World Forum for Harmonization of Vehicle Regulations

**Consideration of draft amendments to existing UN Regulations
submitted by GRSP**

Proposal for Supplement 2 to the 03 series of amendment to UN Regulation No. 127 (Pedestrian safety)

Submitted by the Working Party on Passive Safety *

Figure 12
Windscreen Test Area

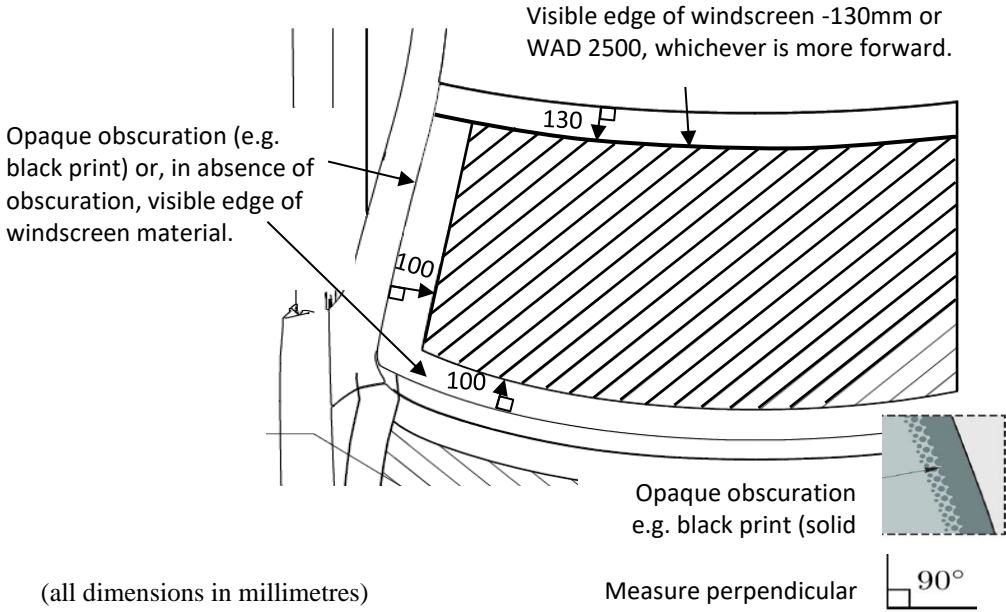
Paragraph 2.44., amend to read and insert Figures 12 and 13:

"2.44. "Windscreen test area" is an area on the outer surface of the windscreen. It is bound (see figure 12):

- (a) In the front, by a line 100 mm rearward to the opaque obscuration of the windscreen. In case of absence of the opaque obscuration, the line is measured from the front visible edge of the windscreen material.
- (b) In the rear, by a WAD 2,500 or a line 130 mm forward to the rear visible edge of the windscreen material, whichever is more forward at a given lateral position.
- (c) At each side, by a line 100 mm inside the opaque obscuration of the windscreen. In case of absence of the opaque obscuration, the line is measured from the side visible edge of the windscreen material.

For (a) and (c): the distances of 100 mm are to be measured with a flexible tape held tautly along the outer surface of the vehicle at an angle of 90° to the tangent line to the opaque obscuration limit or in case of absence of the opaque obscuration, from the visible edge respectively.

For (b): the distances of 130 mm is to be measured with a flexible tape held tautly along the outer surface of the vehicle at an angle of 90 ° to the tangent line to the rear visible edge of the windscreen.

Figure 13
Upper Corner Definition with "Shortest Distance"

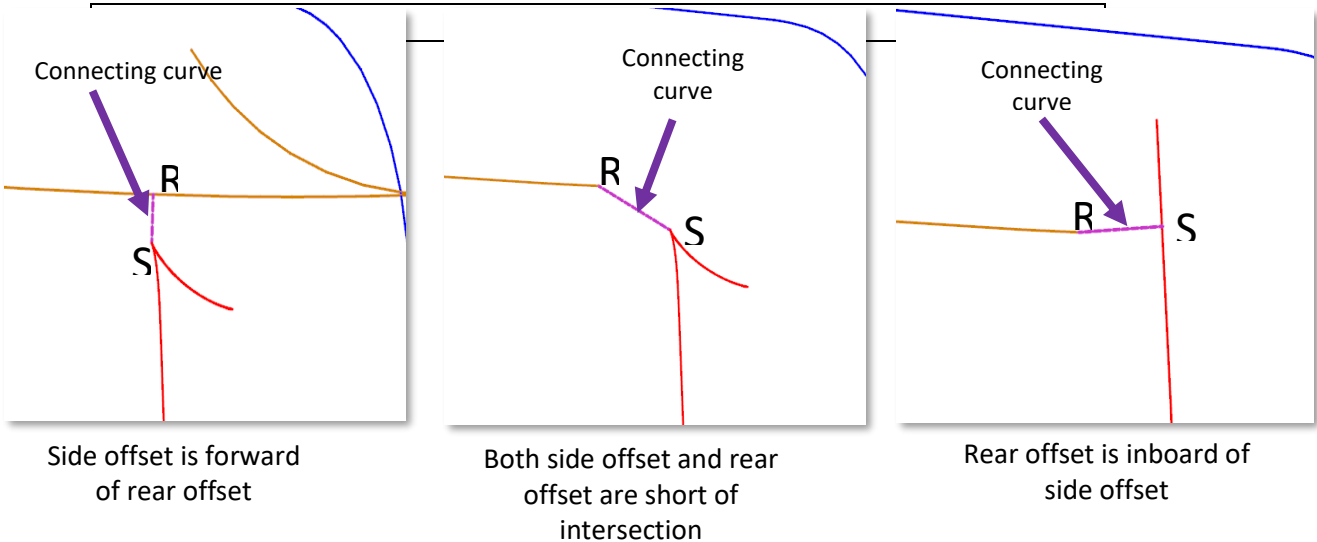
Depending on the geometry, in case there is no intersection between (b) and (c), resulting in an open test area, then the marking shall be modified using the shortest distance to close the open test area (see figure 13).

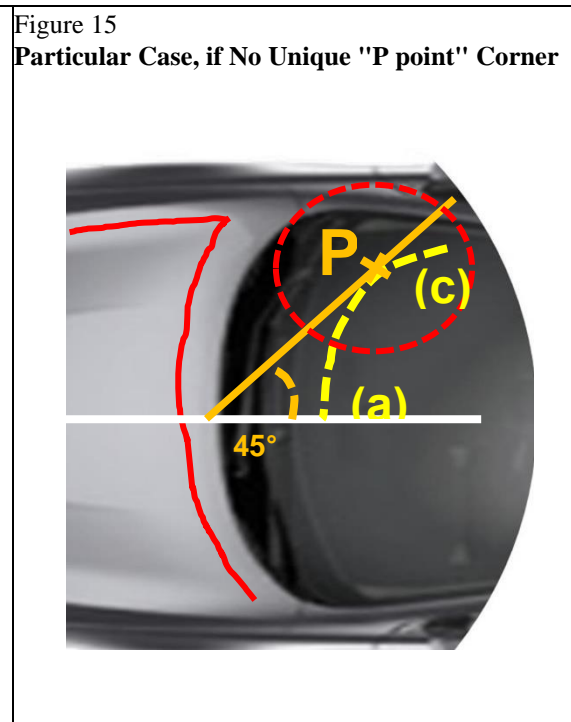
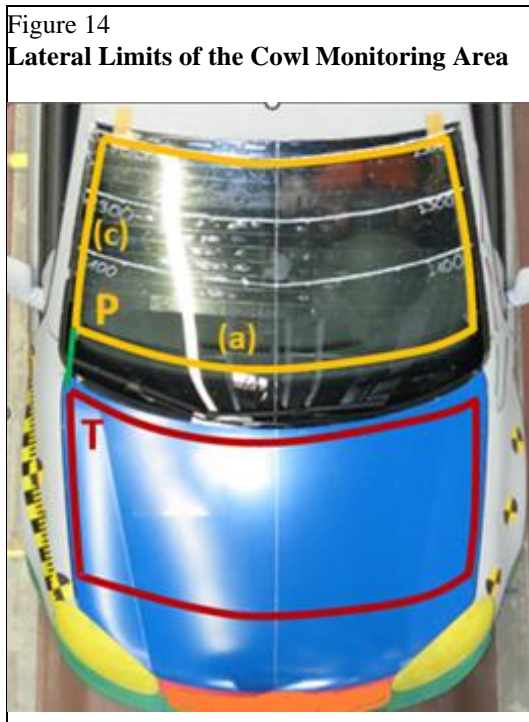
Paragraph 2.45., insert Figures 14 and 15 and amend to read:

At each side, the cowl monitoring area is bound by the TP line (see figure 14), where:

- (a) the "T point" is the rear corner of the bonnet top test area; and
- (b) the "P corner point" is the lower corner of the windscreen test area; using a flexible tape held tautly from point T to P.

If there is no unique "P point" where the lines defined in 2.44 (a) and (c) intersect, then the "P point" is defined by the first contact of a vertical plane intersecting the vertical longitudinal vehicle centre-plane at an angle of 45° with the (a)-(c) transition of the windscreen test area boundary, as shown in Figure 15.

Figure 16

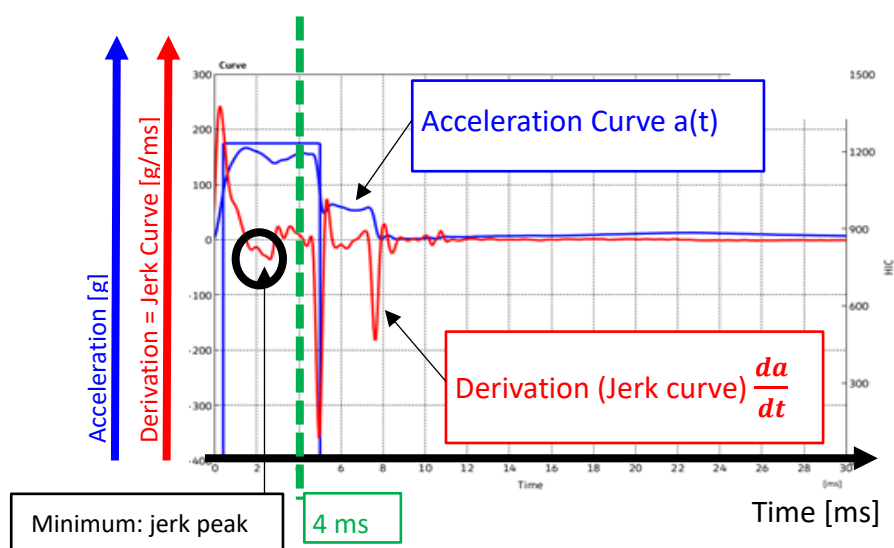
Paragraph 2.48., insert Figure 16 and amend to read:

- (a) The absolute value of the minimum value of the derivation of the headform acceleration versus time is less than 180 g/ms within the first 4 ms after the initial contact of the headform to the windscreen, as shown in Figure 16 ; or

$$\left| \min \left(\frac{da}{dt} \right) \right| < 180 \text{g/ms, for } 0 < t < 4 \text{ms}$$
